KEIMIG 5TH ST
Site Address: 111 5TH ST SE
Jurisdiction: Puyallup
Parcel No.: 728500-0112
Applicant: Samantha Keimig
Permit No.: PLCUP20220162
Interlaken Project No.: SEA-24-068

C1
COVER/TESC
Scale: 1" = 10'

C2
Utility Site Plan
Scale: 1" = 10'

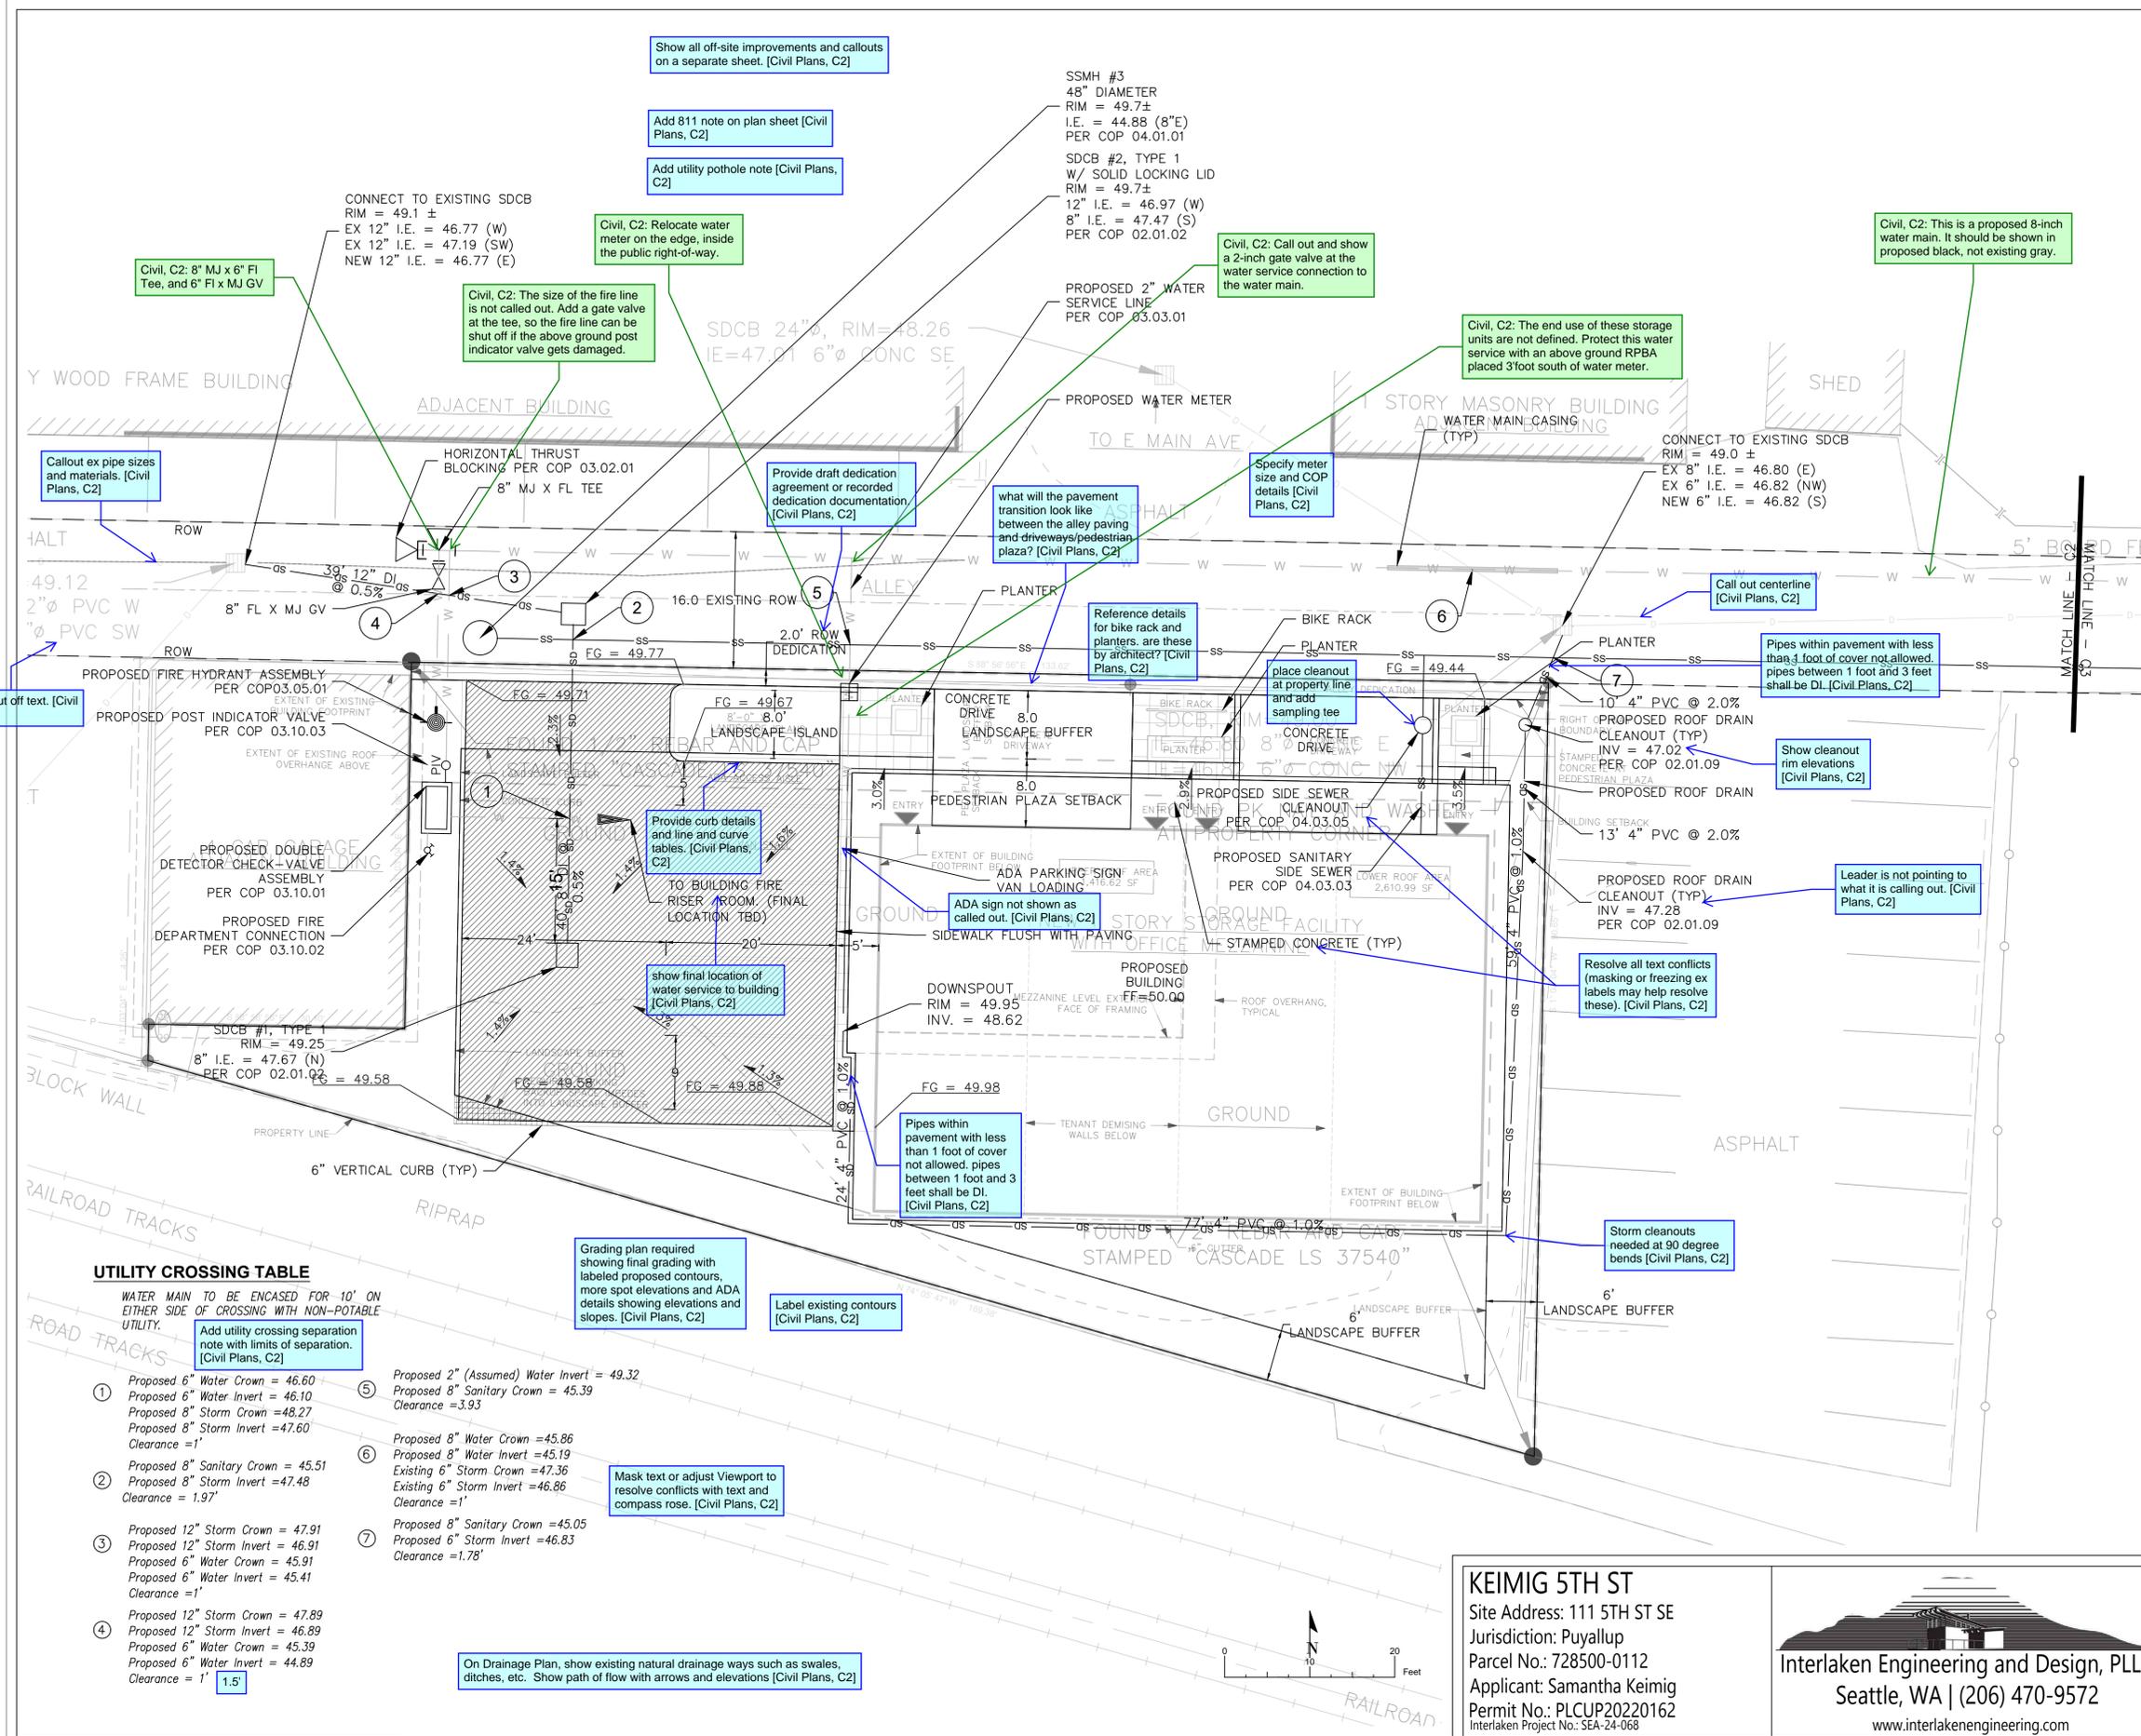
Indicate City-established benchmark (BM) used with number and elevation. [Civil Plans, C1]

Provide cut and fill quantities [Civil Plans, C1]

Provide construction sequence on TESDC Plan per Section 501.6 [Civil Plans, C1]

Provide soil stabilization note based on City Standard Section 501.5 [Civil Plans, C1]

Confirm correct Project Name. The permit was submitted as Keimig Self Storage. Remove "Conditional Use Permit" from project name. [Civil Plans, C1]

Add Other permits note referring to the conditional use permit and other related permits: Preapp, CUP, building, AMRs etc. [Civil Plans, C1]

Replace PRELIMINARY SITE PLAN with CIVL PLANS. [Civil Plans, C1]

Copy of CUP conditions with responses to how and where they are being met. [Civil Plans, C1]

Add City General notes from City Standards Section 2.0 [Civil Plans, C1]

Submit stamped survey with Civil Plans [Civil Plans, C1]

Provide sheet index [Civil Plans, C1]

Proposed and existing rights-of-way and easements shall be clearly identified and dimensioned. [Civil Plans, C1]

Lot size(s) with perimeter distances and bearings of the site shall be shown on the plans. [Civil Plans, C1]

Show current zoning of site and of adjacent properties [Civil Plans, C1]

provide a 2.25" x 3.25" blank block for placeholder on each sheet in or next to title block for City approval stamp [Civil Plans, C1]

This is not the permit number for this project [Civil Plans, C1]

Add date to engineer stamp [Civil Plans, C1]

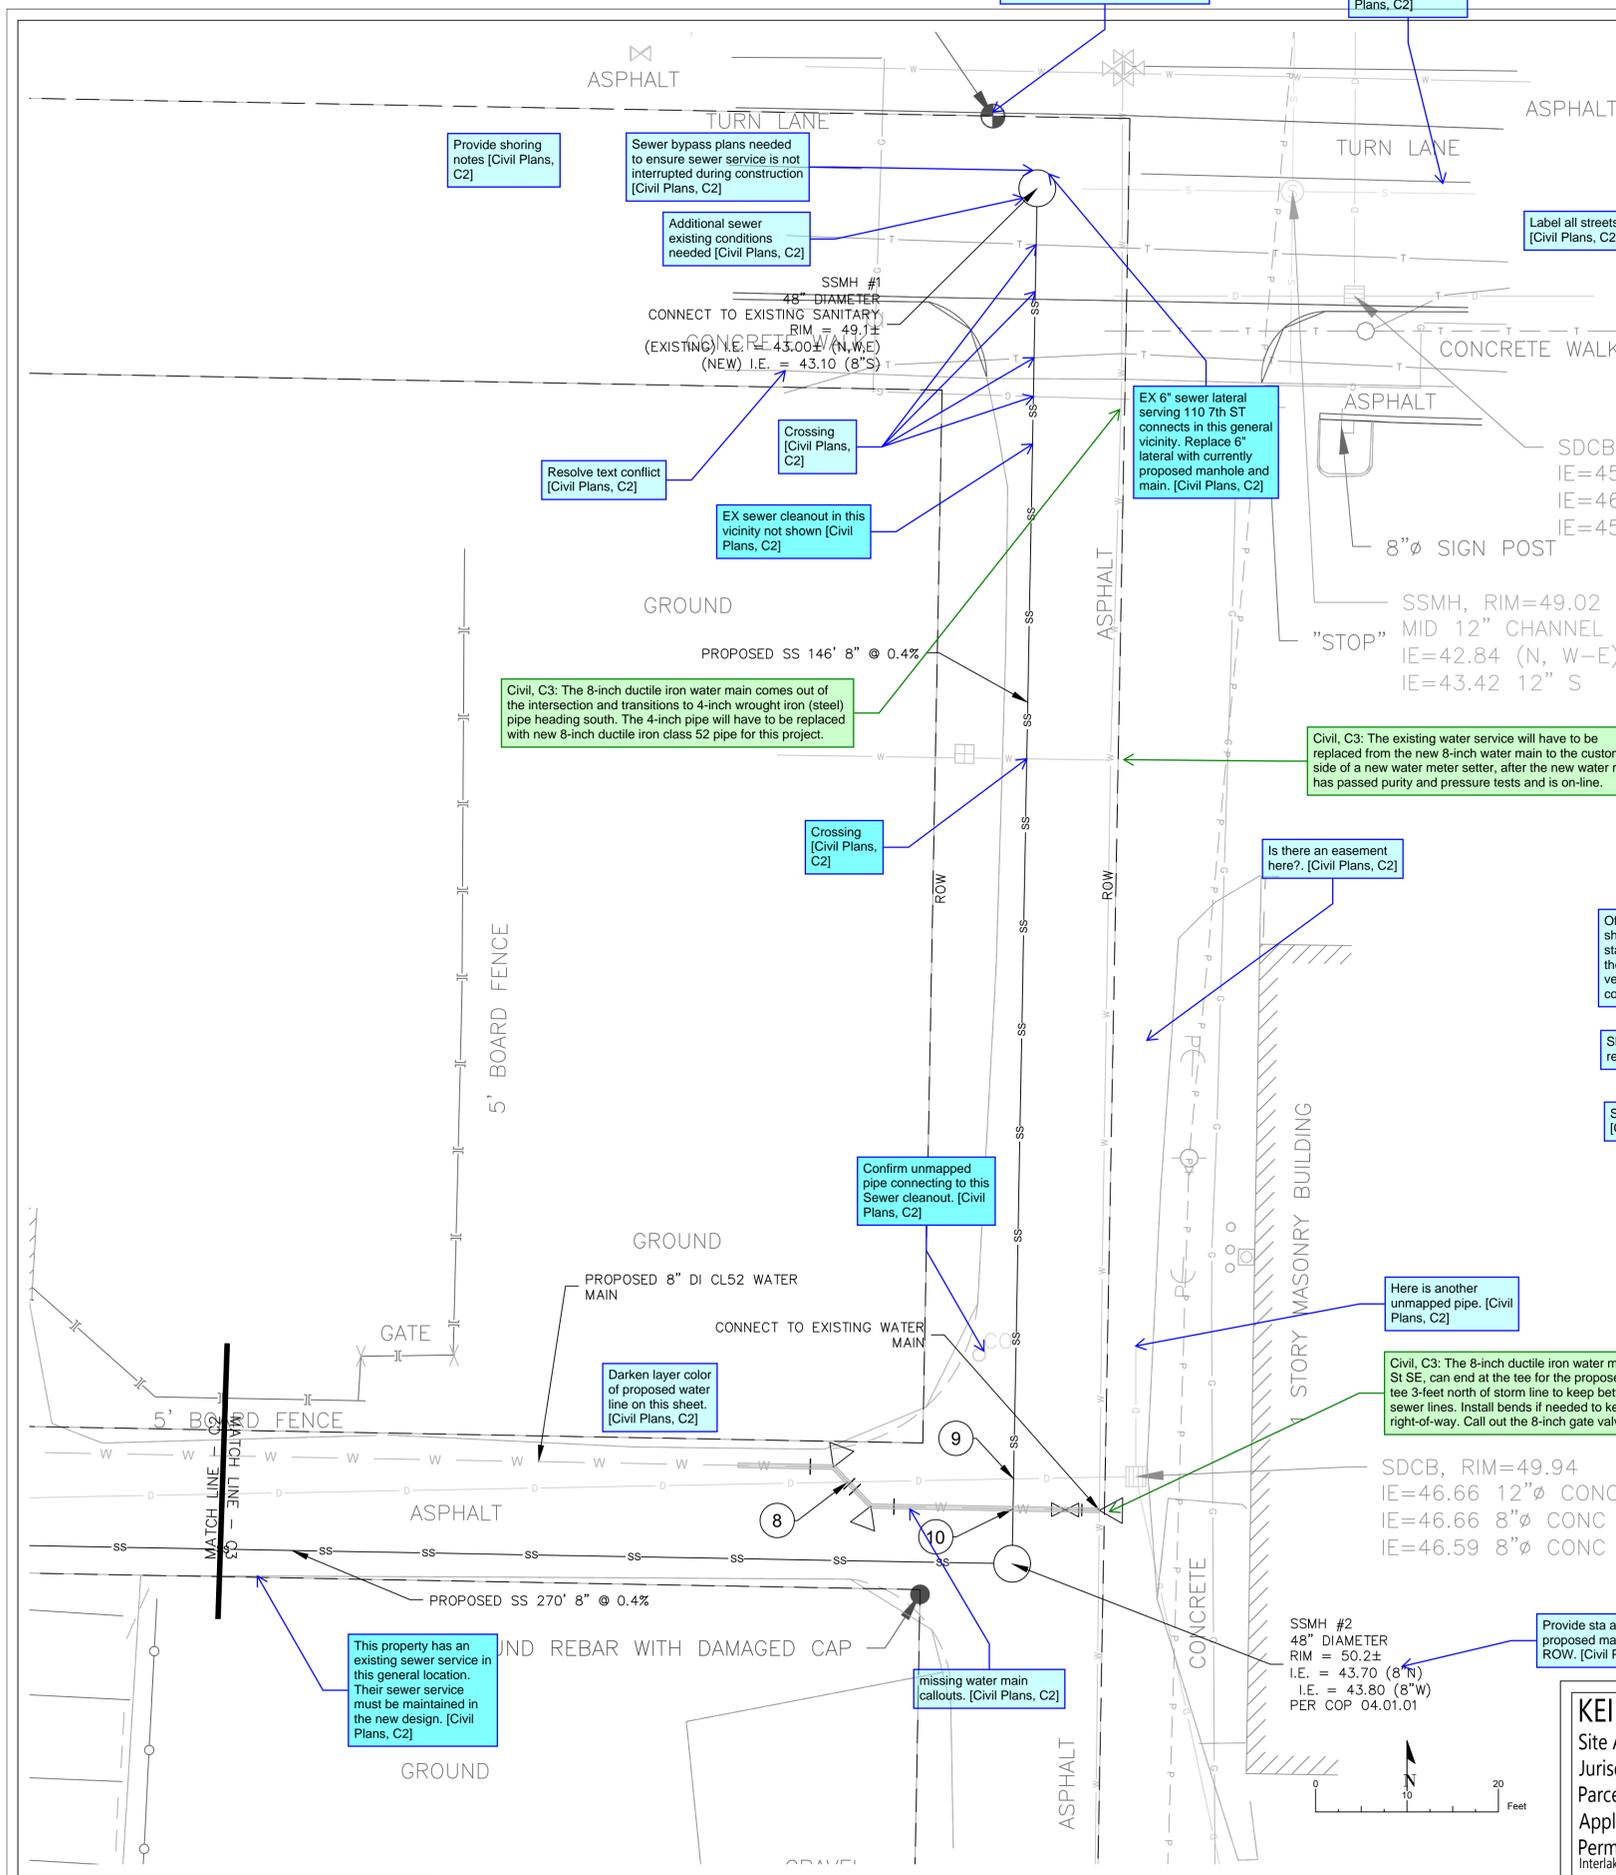
Show all off-site improvements and callouts on a separate sheet. [Civil Plans, C2]

Add 811 note on plan sheet [Civil Plans, C2]

Add utility pothole note [Civil Plans, C2]

Civil, C2: 8" MJ x 6" FI Tee, and 6" FI x MJ GV

Civil, C2: Relocate water meter on the edge, inside the public right-of-way.

Civil, C2: The size of the fire line is not called out. Add a gate valve at the tee, so the fire line can be shut off if the above ground post indicator valve gets damaged.

Civil, C2: Call out and show a 2-inch gate valve at the water service connection to the water main.

Civil, C2: The end use of these storage units are not defined. Protect this water service with an above ground RPBA placed 3' south of water meter.

Civil, C2: This is a proposed 8-inch water main. It should be shown in proposed black, not existing gray.

Callout ex pipe sizes and materials. [Civil Plans, C2]

Provide draft dedication agreement or recorded dedication documentation. [Civil Plans, C2]

what will the pavement transition look like between the alley paving and driveways/pedestrian plaza? [Civil Plans, C2]

Specify meter size and COP details [Civil Plans, C2]

Call out centerline [Civil Plans, C2]

Reference details for bike rack and planters, are these by architect? [Civil Plans, C2]

Pipes within pavement with less than 1 foot of cover not allowed. pipes between 1 foot and 3 feet shall be DL. [Civil Plans, C2]

Remove cut off text. [Civil Plans, C2]

Provide curb details and line and curve tables. [Civil Plans, C2]

ADA sign not shown as called out. [Civil Plans, C2]

Leader is not pointing to what it is calling out. [Civil Plans, C2]

show final location of water service to building [Civil Plans, C2]

Resolve all text conflicts (masking or freezing ex labels may help resolve these). [Civil Plans, C2]

Pipes within pavement with less than 1 foot of cover not allowed. pipes between 1 foot and 3 feet shall be DL. [Civil Plans, C2]

Storm cleanouts needed at 90 degree bends [Civil Plans, C2]

Grading plan required showing final grading with labeled proposed contours, more spot elevations and ADA details showing elevations and slopes. [Civil Plans, C2]

Label existing contours [Civil Plans, C2]

Mask text or adjust Viewport to resolve conflicts with text and compass rose. [Civil Plans, C2]

On Drainage Plan, show existing natural drainage ways such as swales, ditches, etc. Show path of flow with arrows and elevations [Civil Plans, C2]

Add utility crossing separation note with limits of separation. [Civil Plans, C2]

C5
 Details 1
 Scale: As Noted

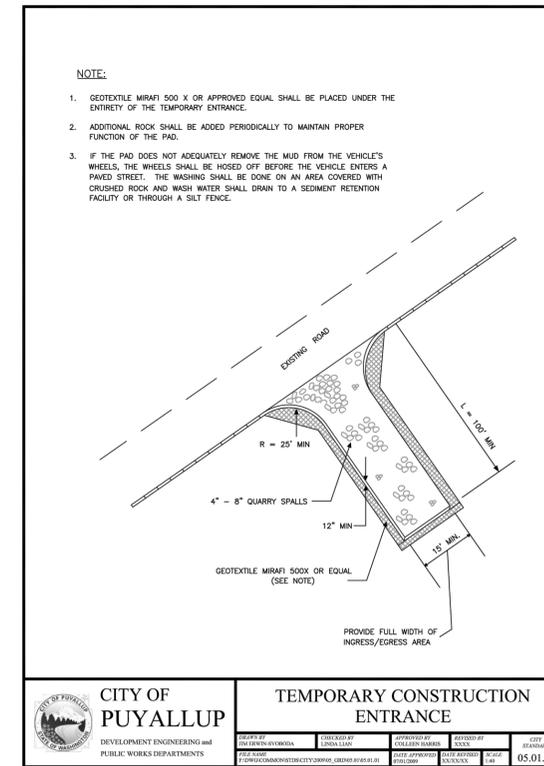
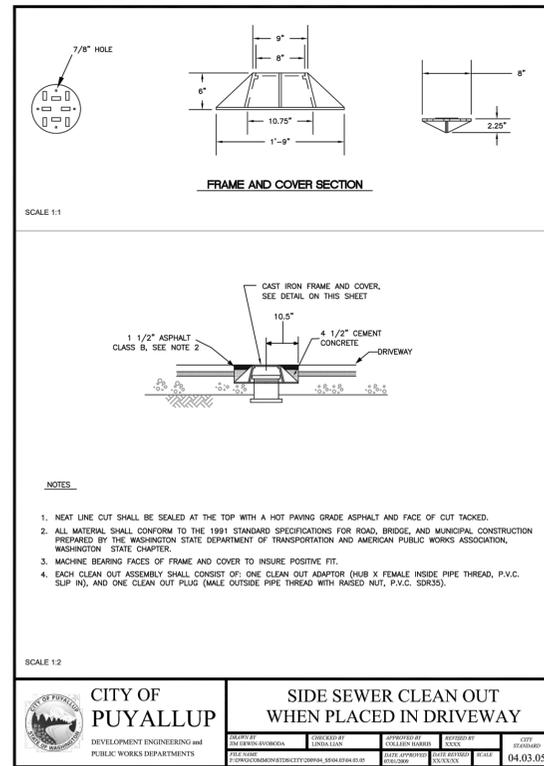
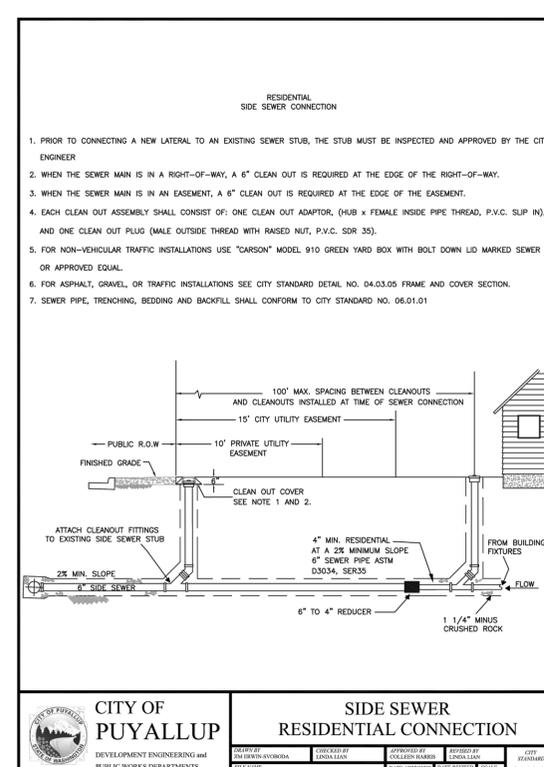
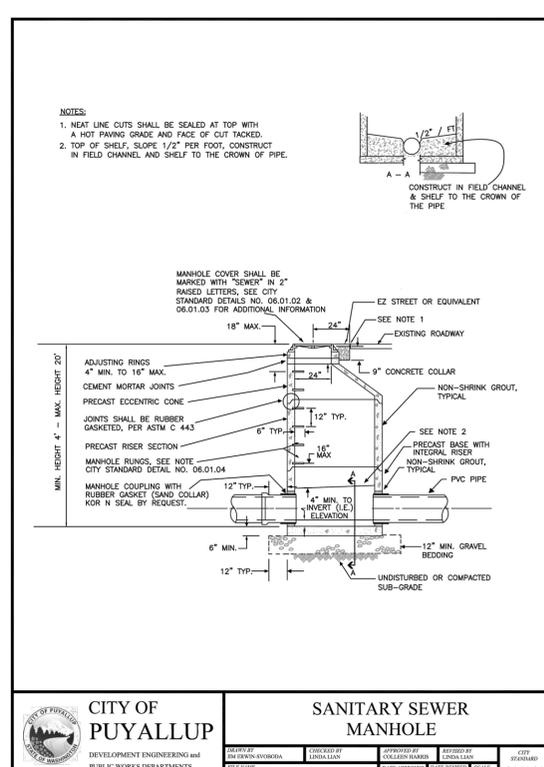
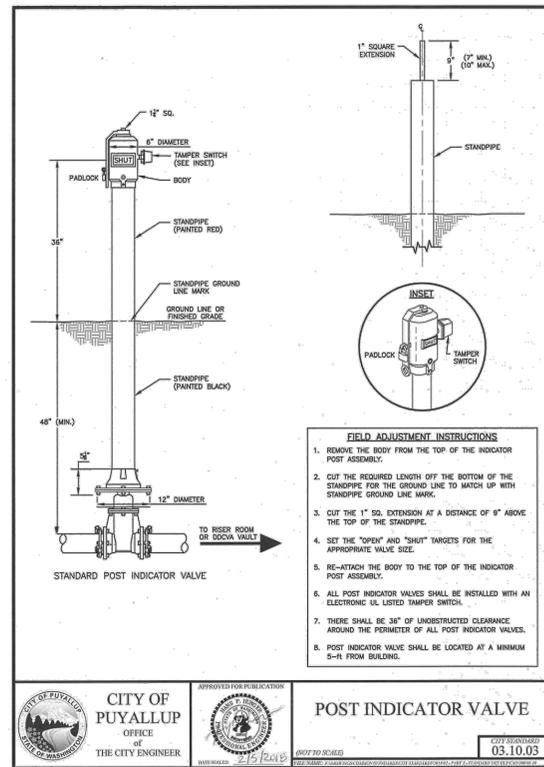
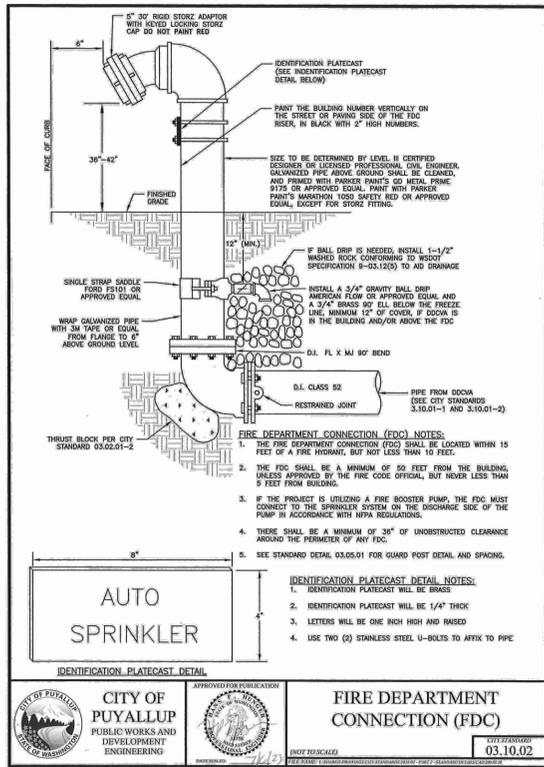
Provide the following details and any others that apply:
 alley cross section
 half street improvement
 street patch
 utility crossing
 utility locations
 approach site distance
 catch basin frame and grate monument
 water valves
 trust blocking table
 vertical blocking if applicable
 water vault
 utility trench bedding and backfill
 Manhole ring and cover
 Manhole step and ladder
 [Civil Plans, C5]

Civil, C5: Add City Standard details 03.01.01 and 03.04.02 to this plan set.
